## DEVIATION REQUEST AND DECISION FORM

Project Name : Skyline at Lorson Ranch  
Schedule No.(s) : 5500000440, 5500000274, 5500000275, 5513300005, 5513310105  
Legal Description : See Attached

SKYLINE AT LORSON RANCH

DEVIATION 2  
EXHIBIT

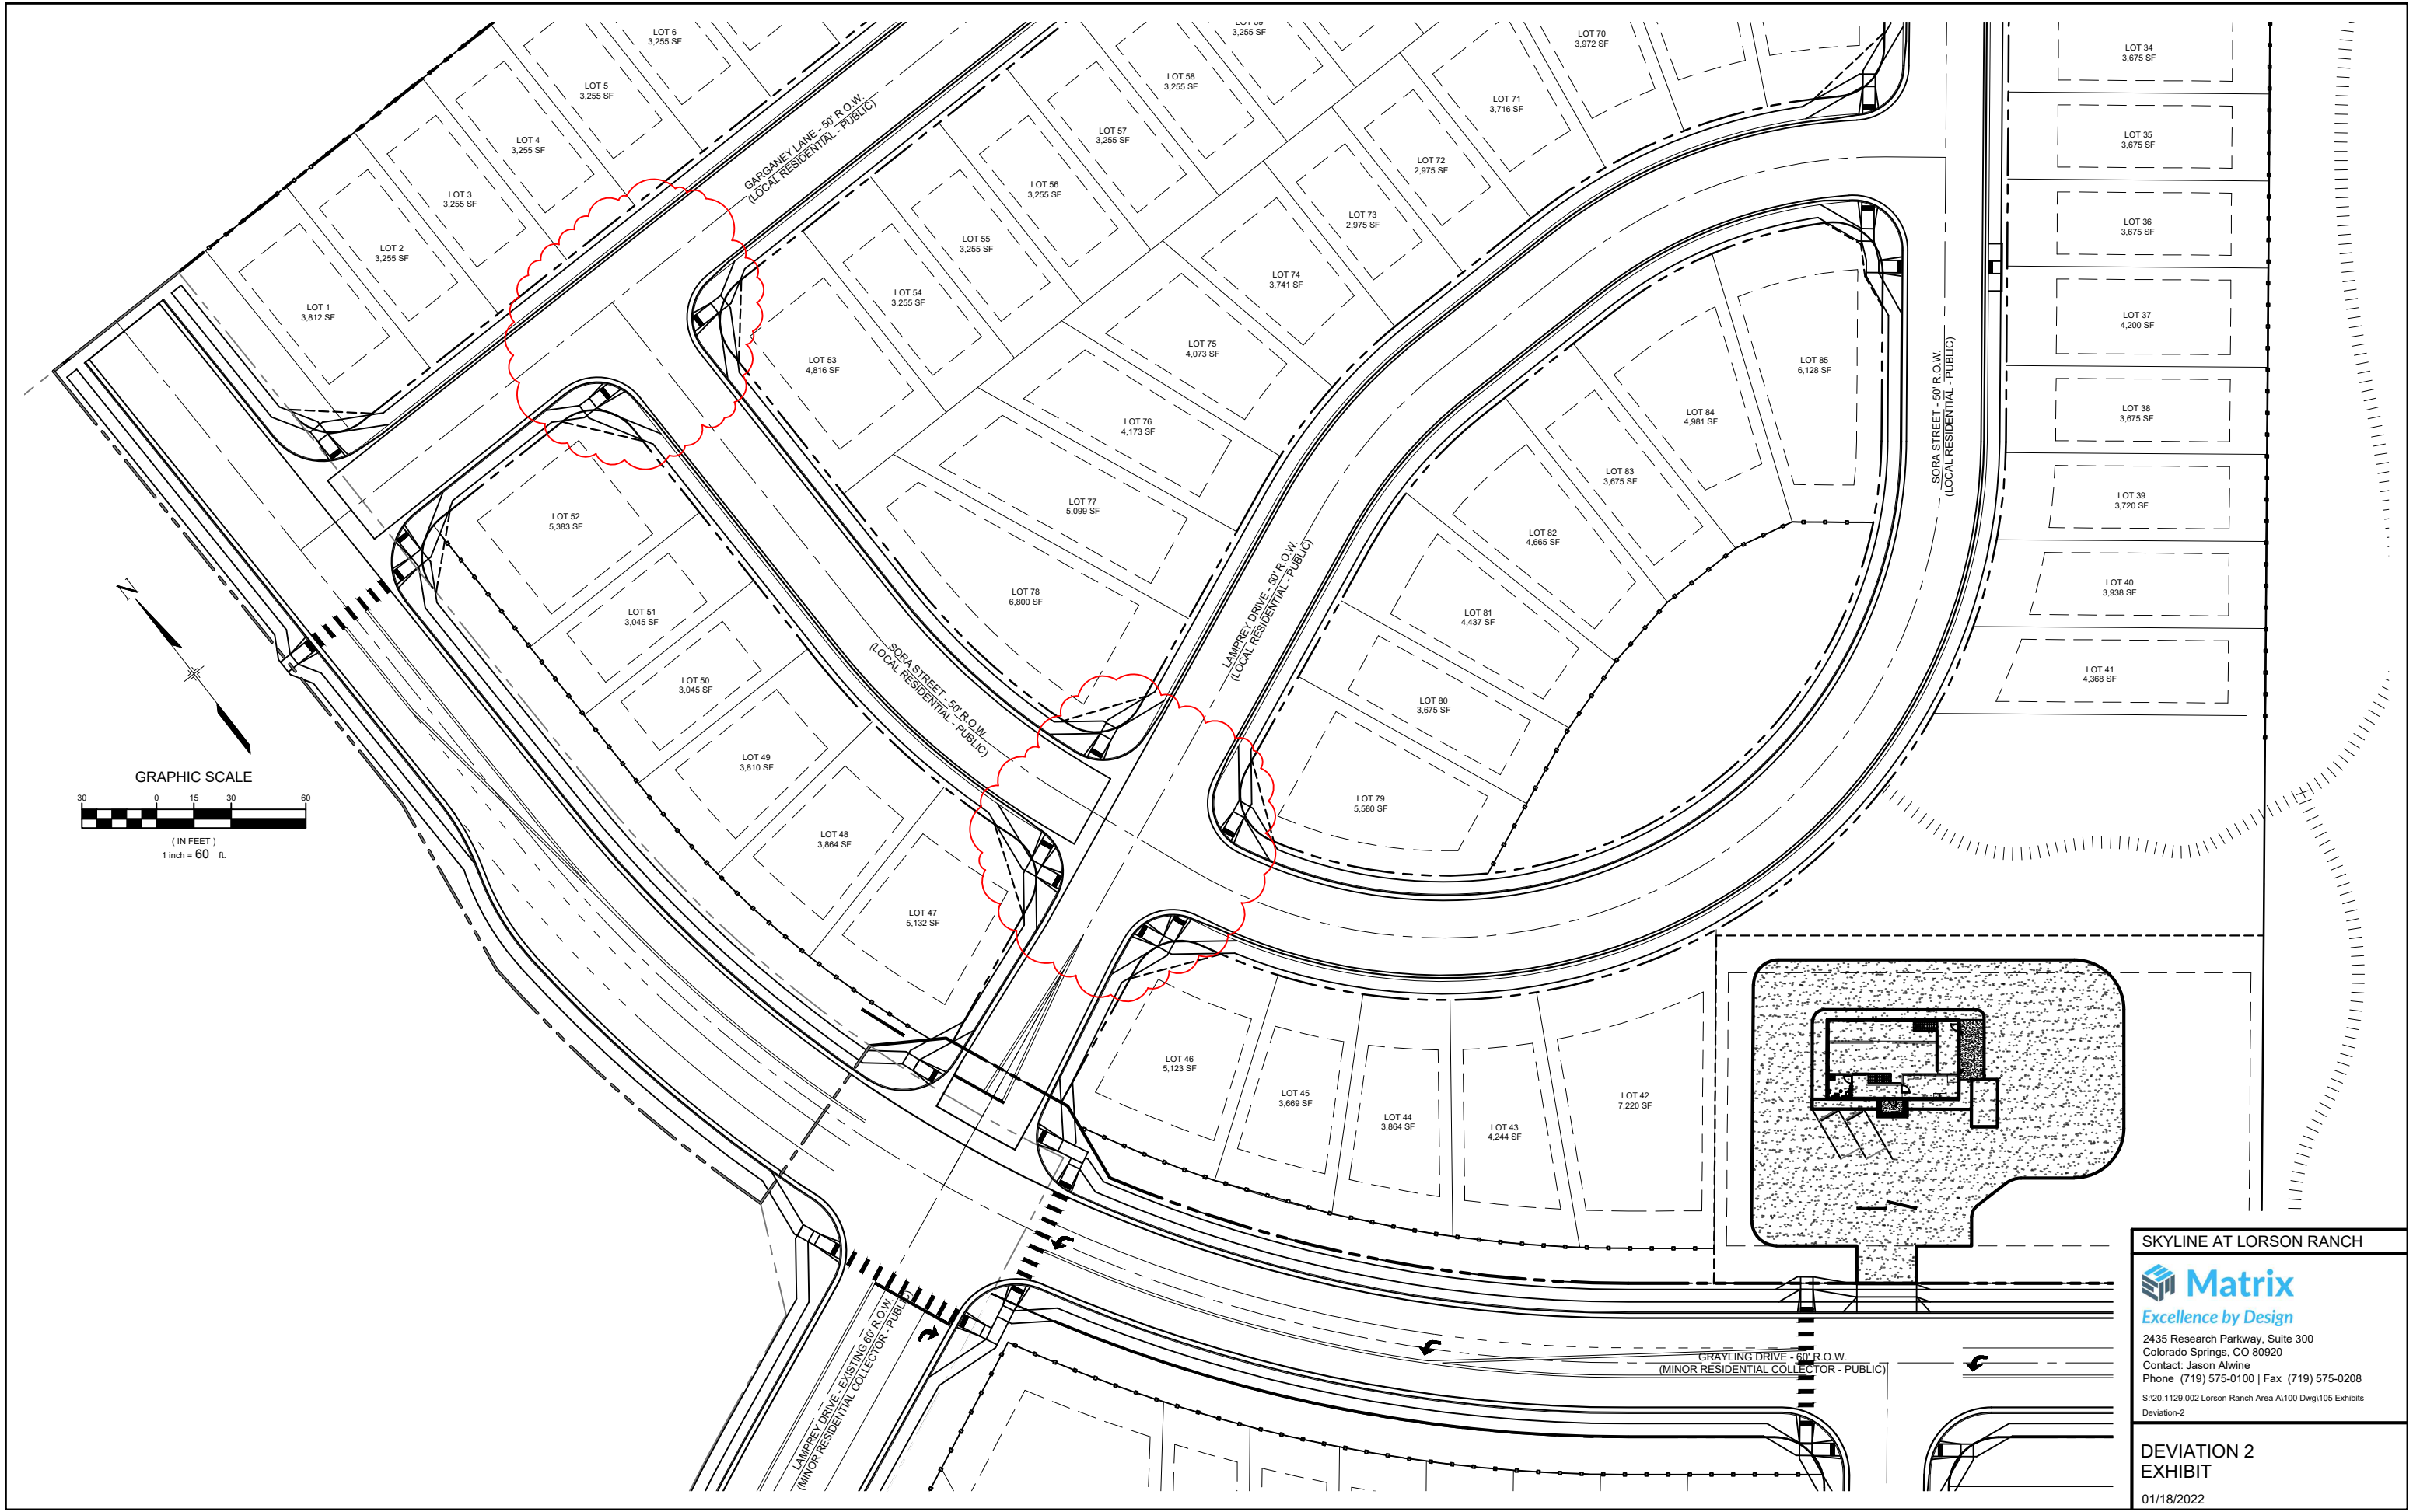
Allow only two pedestrian ramps to be constructed at the T-intersection of Garganey Lane and Sora Street and allow only six pedestrian ramps to be constructed at Sora Street and Lamprey Drive.

Both the intersections are in proximity of another intersection with all ramps installed as required. Installation of all corner ramps at these two intersections is not feasible as the grading cannot meet ADA requirements along the ADA curb returns. However, the intersections are providing multiple access points and does not limit pedestrian movements.

Elimination of ramps at each of the intersections will not impede pedestrian movements and will result in safer pedestrian crossing due to grading concerns and inability to meet ADA slope requirements (where required). A pedestrian will be able to cross at alternate locations within approximately 85' or less of the eliminated ramps.
